Project	IEEE 802.16 Broadband Wireless Access Working Group < http://ieee802.org/16 >	
Title	Remedy of EAP-in-EAP double EAP mode	
Date Submitted	2005-07-15	
Source(s)	Junhyuk Song, Jicheol Lee, Alper Yegin Samsung Electronics Yoshihiro Ohba Toshiba	junhyuk.song@samsung.com jicheol.lee@samsung.com alper.yegin@samsung.com yohba@tari.toshiba.com
Re:	IEEE P802.16e/D9	
Abstract	Remedy of double EAP mode Authentication	
Purpose	Adopt this contribution as a remedy of EAP-in-EAP double mode	
Notice	This document has been prepared to assist IEEE 802.16. It is offered as a basis for discussion and is not binding on the contributing individual(s) or organization(s). The material in this document is subject to change in form and content after further study. The contributor(s) reserve(s) the right to add, amend or withdraw material contained herein.	
Release	The contributor grants a free, irrevocable license to the IEEE to incorporate material contained in this contribution, and any modifications thereof, in the creation of an IEEE Standards publication; to copyright in the IEEE's name any IEEE Standards publication even though it may include portions of this contribution; and at the IEEE's so

Figure 133a- AK with PMK and PMK2
(EAP-based authorization and Authenticated EAP-based authorization)

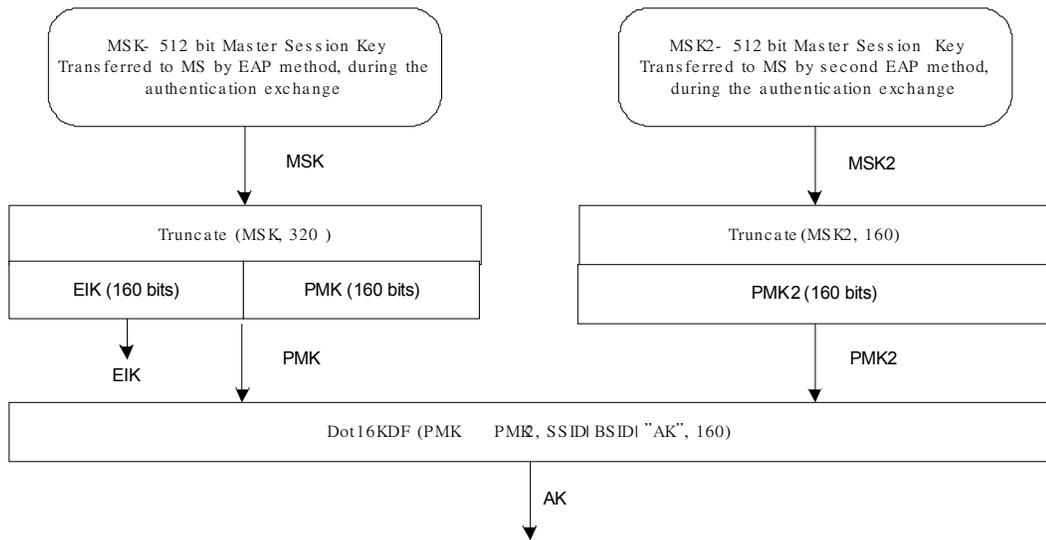
[Add following figure and text right after figure 133 in page 216 of 802.16e/D9]

Figure 133a outlines the process to calculate the AK when EAP in EAP mode authentication exchange has taken place, first EAP yielding EIK and MSK and second EAP yielding MSK2.
